寄件者: Thomas Wan <[redacted]>
寄件日期: 2026年09月15日星期二 9:01
收件者: Adrian Tsz Hin TAM/PLAND
副本: Kit Lo; William Shu Tai WONG/PLAND; Johnny Chung Yin LAM/PLAND
主旨: RE: Planning Application No. A/NE-MUP/236
附件: Lots 188(Part) and 189RP, Demarcation District No.38 (V1).pdf

Please find my comments below regarding the swept path analysis:

Drawing Title:
11m Swept Path 1

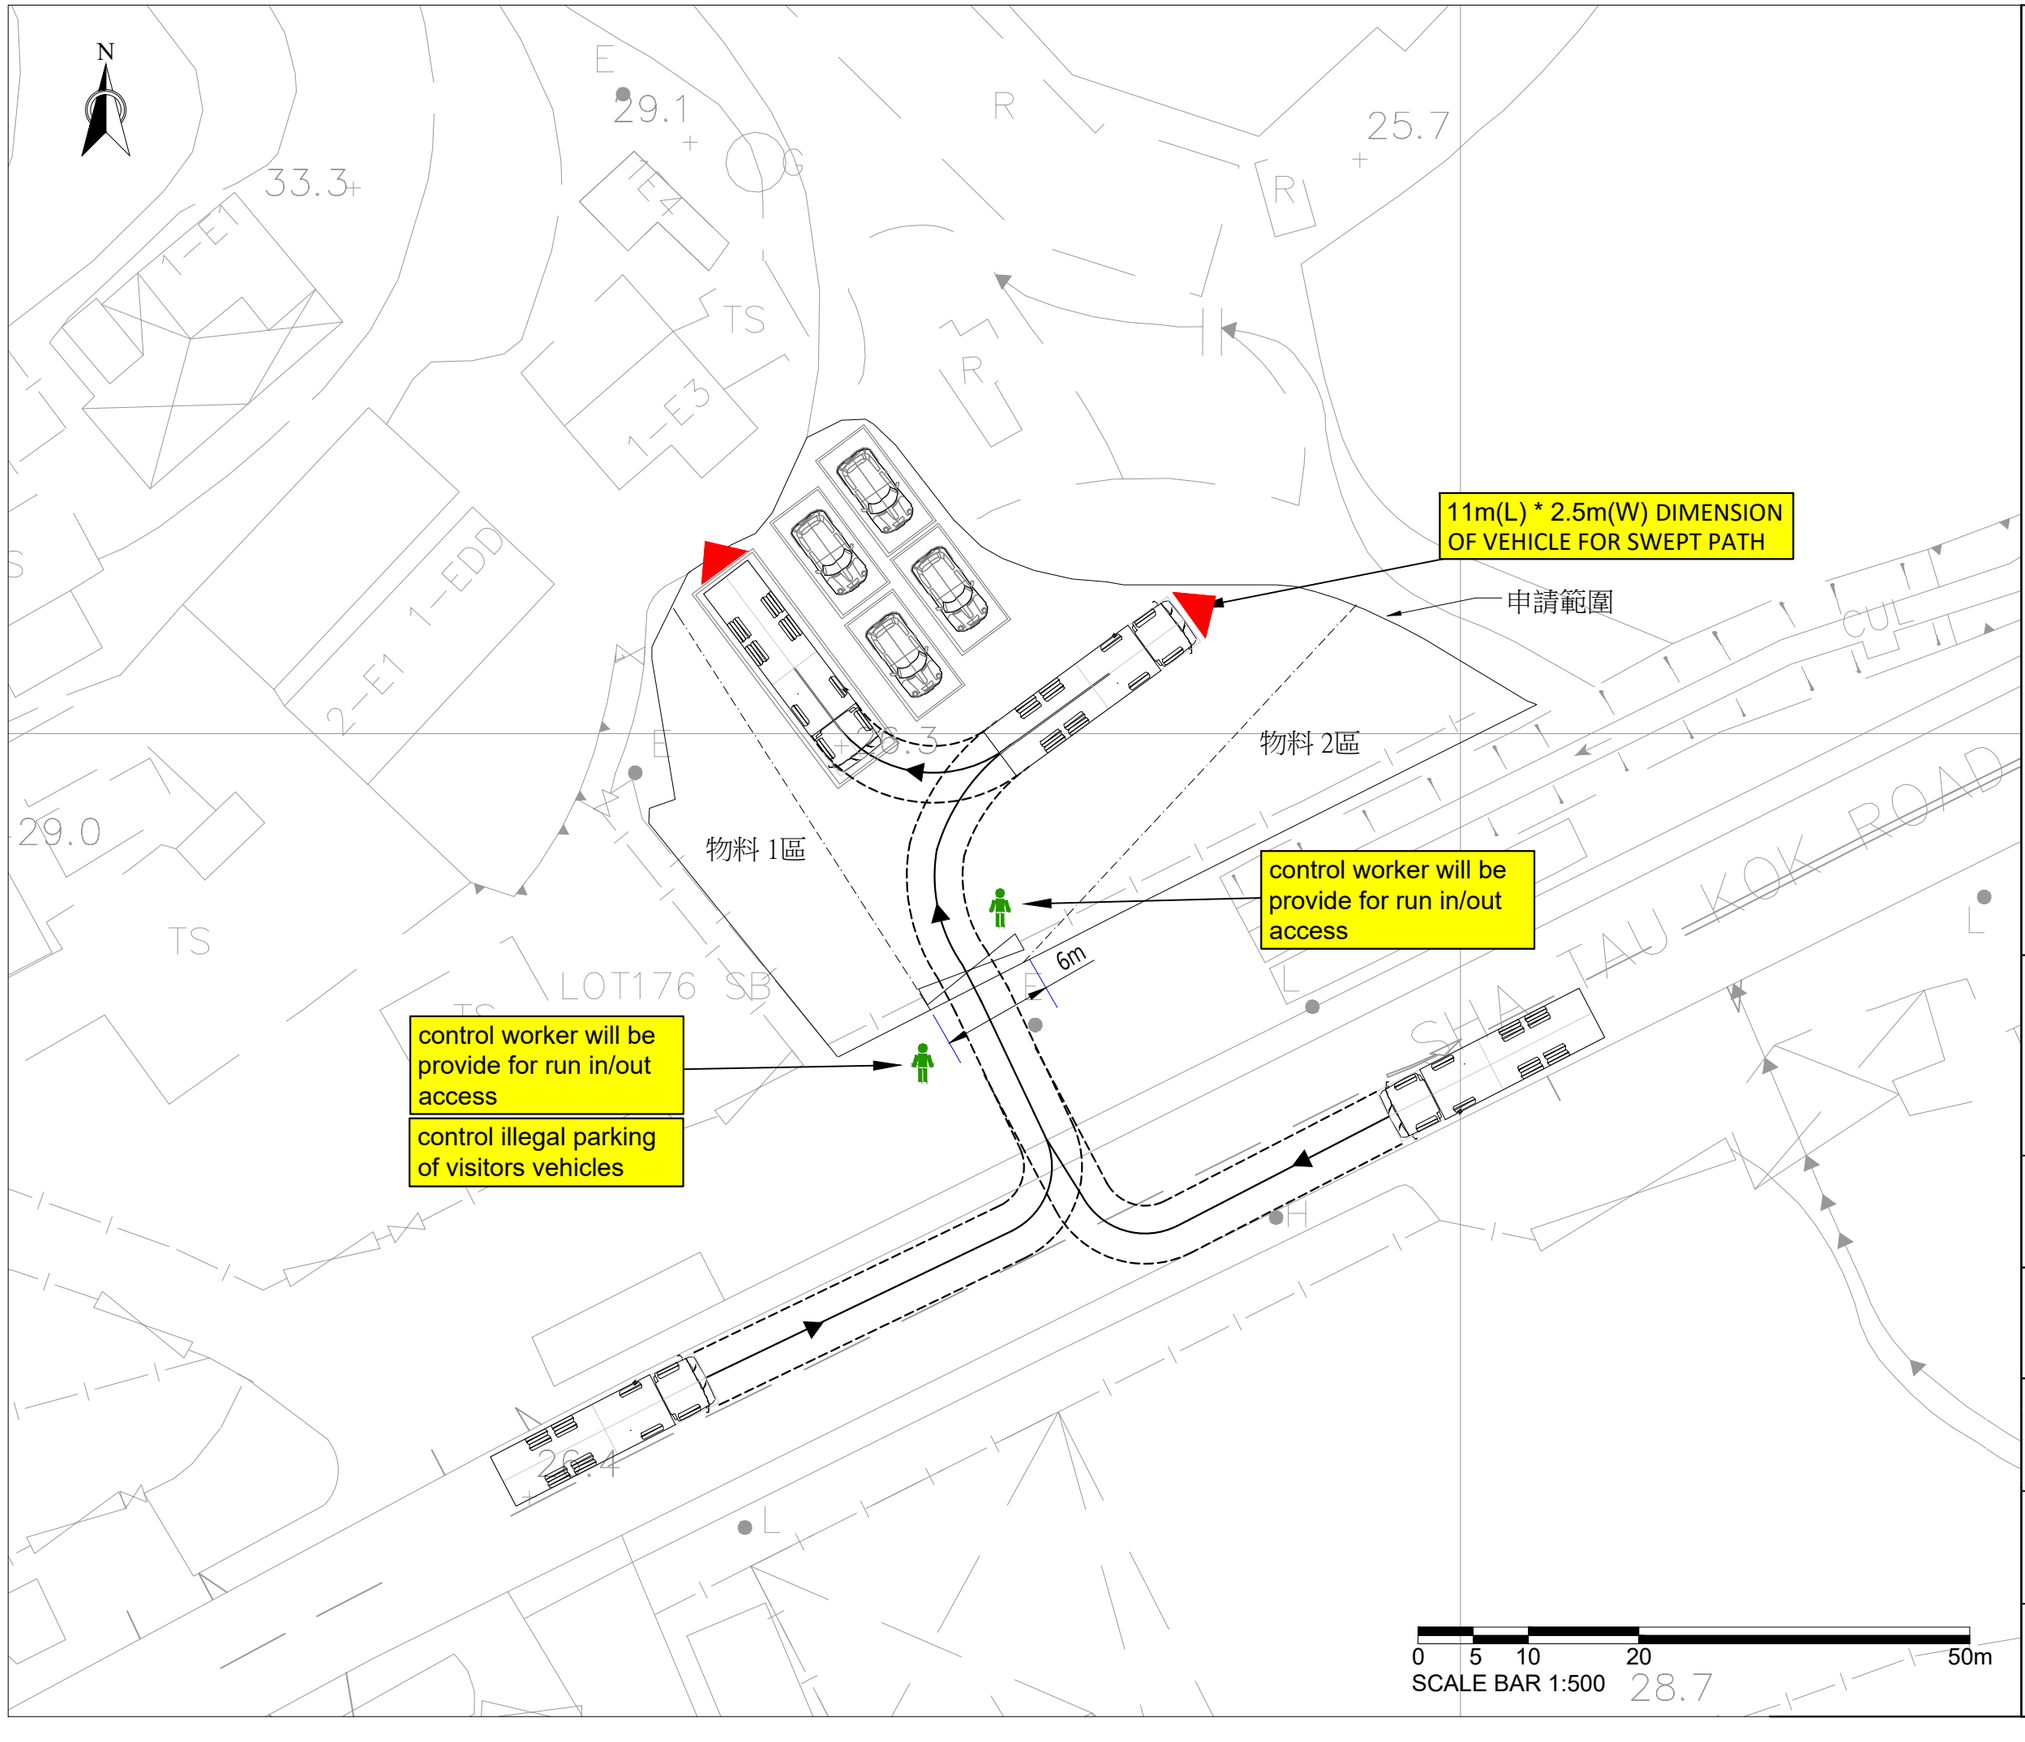
1. Swept path analysis should demonstrate that HGV would not encroach onto the opposite lane when entering/leaving Sha Tau Kok Road to/from the application site; and
2. According to your swept path analyses for HGV entering and leaving the application site, the run-in/out will be over 30m width. Excessive width of the ingress/egress point is normally not recommended; and
3. It is noted 12.8m (L) vehicle is used for swept path analysis, which is inconsistent with your proposed HGV parking space dimension (11m x 3.5m). You should clarify whether a vehicle of this dimension will be used in your operation.

Drawing Title:
7m Swept Path 1

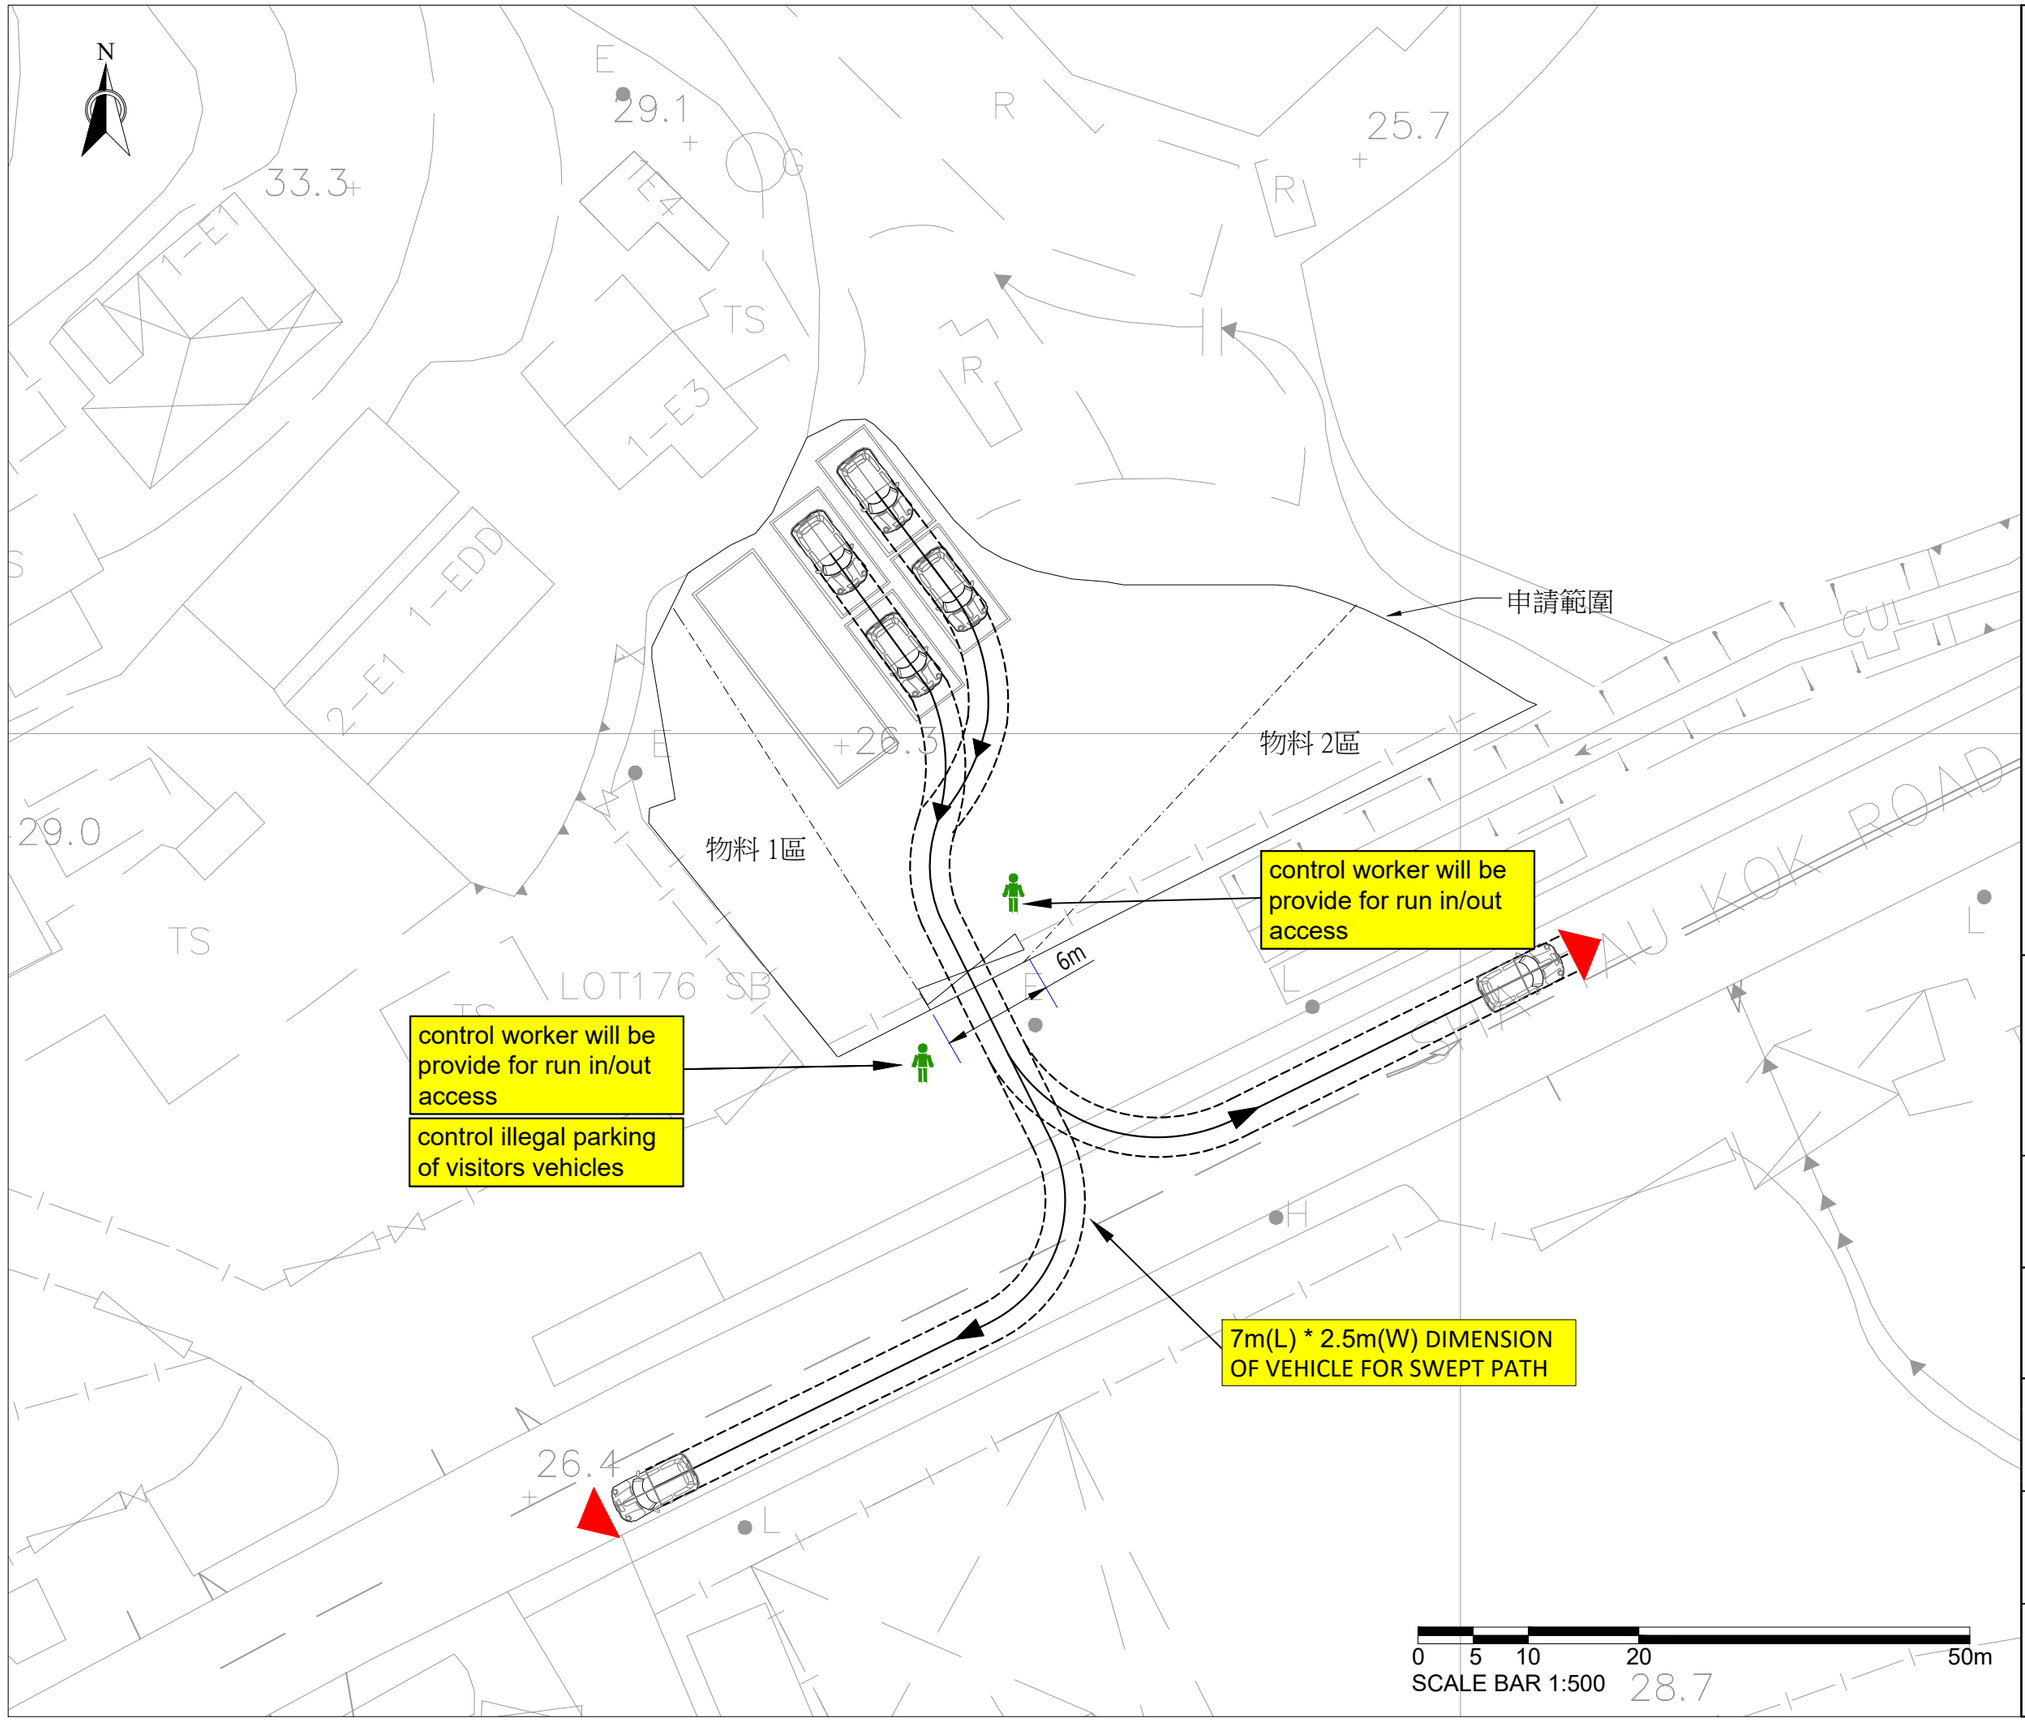
2. the submitted swept path analysis for HGV does not accurately reflect the actual situation of the maneuvering of the HGV entering and exiting the application site, within the application site and into/out of the parking spaces;

DWG updated ,please check.
